VALIDATION OPINION FOR THE REVISED
MONITORING PLAN:

Samsung Electronics SF₆ abatement project

UNFCCC Ref. No. 3333

REPORT No. 2011-03

Picture 2. The revised Monitoring Diagram for Project Activity (Revised PDD, ver. 6.0)

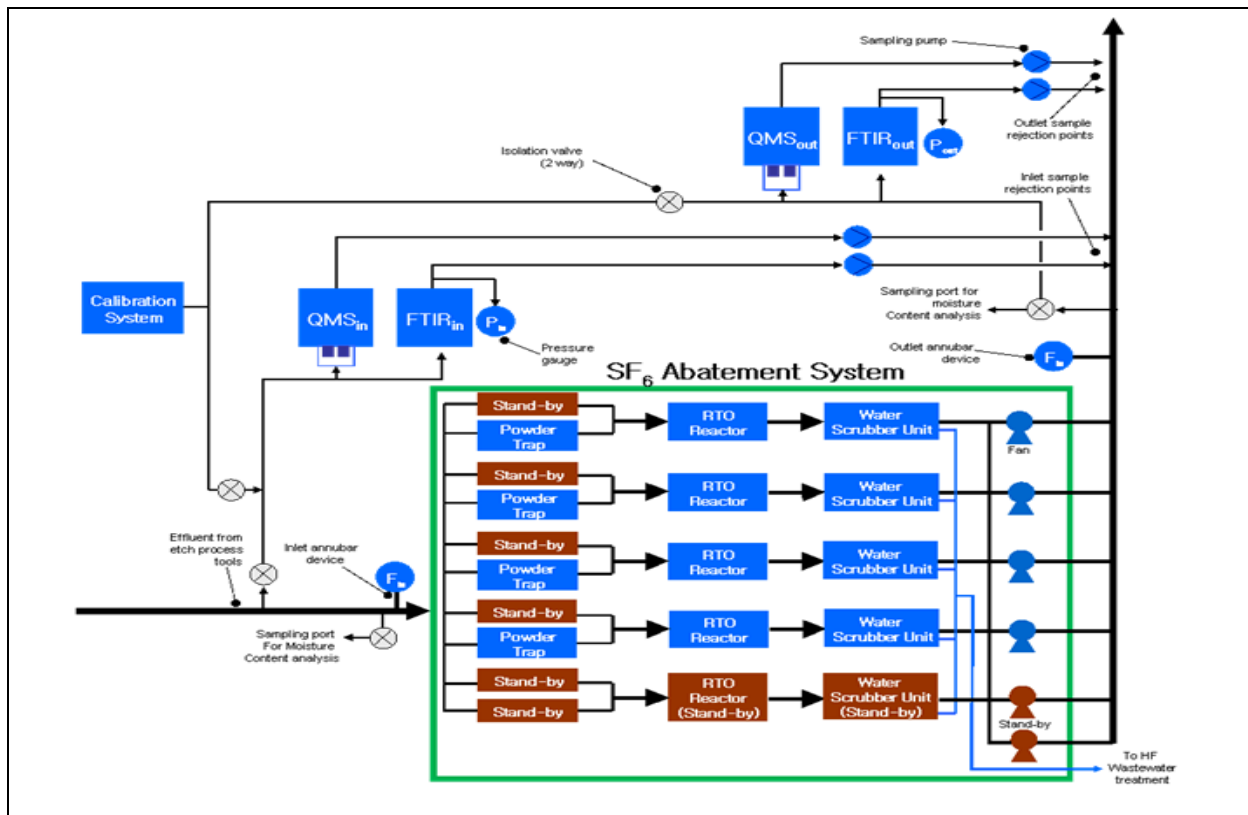
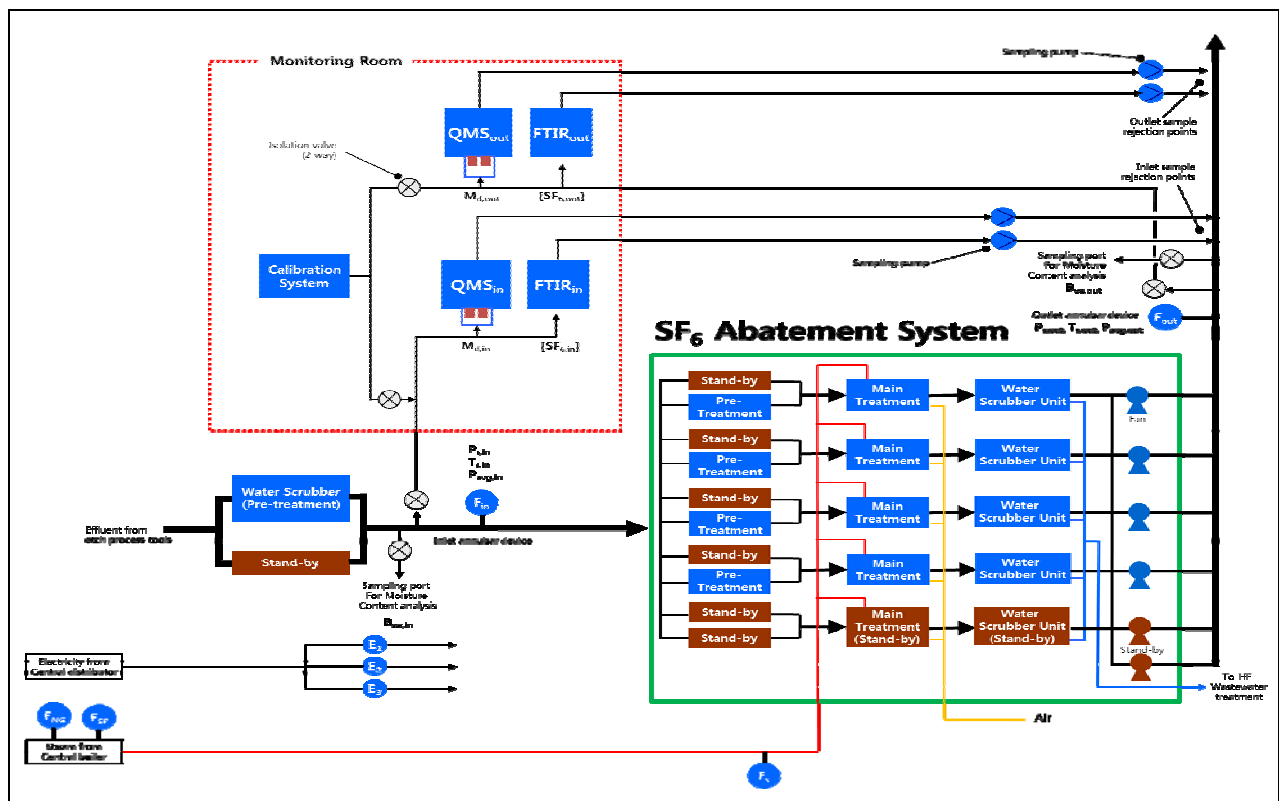
- i) As described in 3.2 Project Design, the installation of pre wet-scrubber and steam pipe is determined for prevention of corrosion in the abatement facility. Accordingly, the pre wet-scrubbers and steam line are added in the revised monitoring diagram.
- ii) The monitoring points for steam use are newly added in revised monitoring diagram. For calculation of project emission from steam use, 3 flow meters for LNG consumption, Steam generated at the central boiler and Steam consumed at the project are installed before connecting to the abatement system. It measures the amounts of $C_{NG, plant}$, $C_{steam, y}$, $C_{steam, plant, y}$ directly and continuously.
- iii) The monitoring diagram in the registered PDD did not reflect the monitoring point of electricity meters including in the MP of registered PDD. Hence, the monitoring points of

electricity consumption for the project activity are included in revised monitoring diagram. For measuring the electricity consumption of project activity, 3 major electricity meters are installed and each meters are measured for QMS and FTIR, for abatement system operation (heater and fan), and for general use in control room.

- i) As described in 3.2 Project Design of this report, validation team found that the implementation of the project does not in accordance with the description contained in the registered PDD. Because PP determined the pre wet-scrubber and steam use for prevention of corrosion incurred in the pilot test stage of project activity. Accordingly, validation team assessed on changes from the project activity as described in the registered PDD and PP has requested the changes from the project activity as described in the registered PDD to the UNFCCC, separately. For reflecting the actual activity in revised MP, the installation of pre wet-scrubber and steam pipe is clearly depicted in the revised monitoring diagram.

- ii) Monitoring Diagram is revised due to add the monitoring parameters. From the inclusion of steam use for the project activity, 3 monitoring parameters ($C_{\text{NG, plant}}$, $C_{\text{steam, y}}$, $C_{\text{steam, plant, y}}$) will be monitored by each meter at the project site. Hence, validation team checked that the meters involved are all pointed in the revised monitoring diagram.

- iii) According to the parameter ‘Quantity of electricity consumed by the project electricity consumption source j in year y ($EC_{\text{pj, y}}$)’ including the MP of registered PDD, it demonstrates that the meter will be measured continuously using electricity meters. However, the monitoring diagram in the registered PDD does not include the monitoring point of electricity meters. Accordingly, the revised monitoring diagram adds the electricity meters. Validation team found that PP installed 3 meters for measuring electricity consumption for

monitoring. The major electricity consumption parts are divided as 3 parts in the boundary. Each of part are electricity consumption for QMS and FTIR, for abatement system operation (heater and fan), and for general use in control room. Consequently, $EC_{pj,y}$ will be calculated by sum of 3 meters. These meters will be periodically calibrated in accordance with the description of 'QA/QC procedure' in registered PDD.

Through physical site visit and interview with PP, the validation team concluded that the revised monitoring diagram reflects current status of the site well and it does not affect level of accuracy and completeness of the result of emission reduction.
